# Technical Issues

## 1. Incompatibility of Existing EDRs

## Electronic architecture redesign

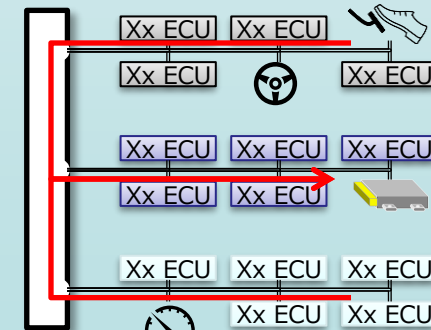
Changes to EDR specifications can affect the entire electrical and electronic architecture of the vehicle, potentially necessitating a fundamental redesign.

From the perspectives of power hold time, memory and processing load, and vehicle architecture design, applying the regulatory specifications proposed by each CP to existing vehicles is extremely difficult.

# Lead Time

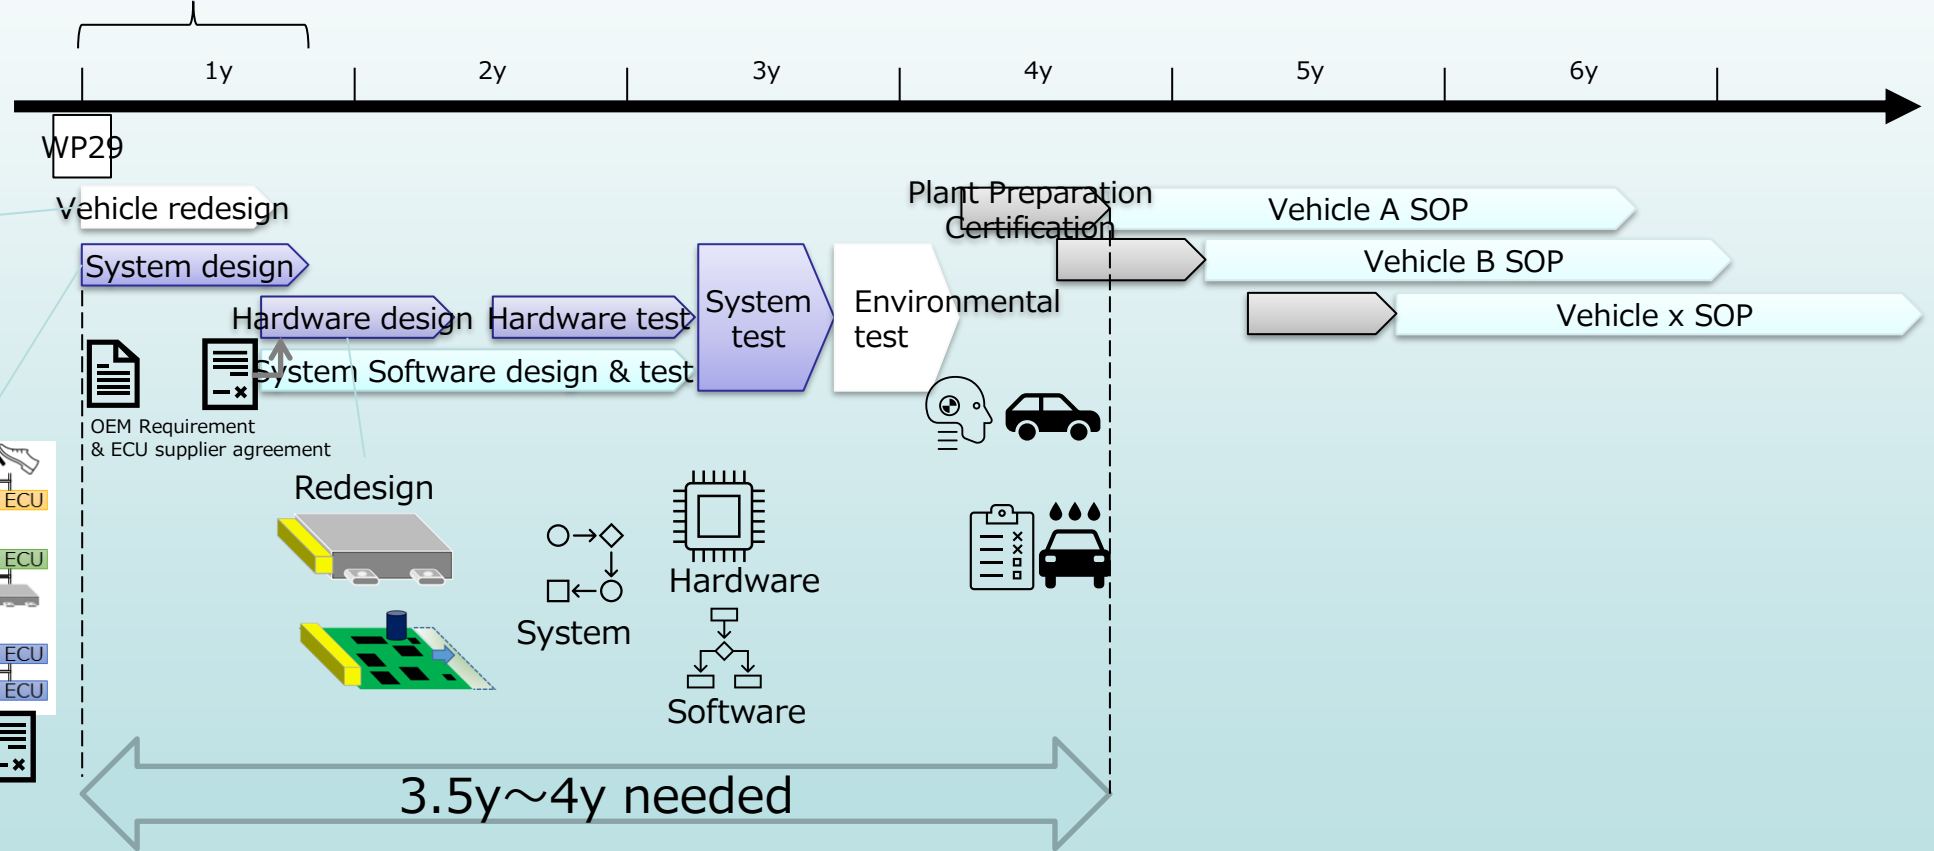
The OEM will redesign the vehicle and the E&E architecture.  
 The OEM will redesign the requirements specifications.  
 The OEM will re-sign a development contract with the supplier.  
 The supplier will then begin development of the ACU.  
 So, we need additional lead time(0.5 ~1 years) = Total 3.5 ~ 4 years.

Current schedule	'26.11	'27.11	'28.11	'29.11	'30.11
In case of schedule delay	'27.3	'28.3	'29.3	'30.3	'31.3

Based on the current schedule, OICA/CLEPA proposes the new vehicle types from 2031
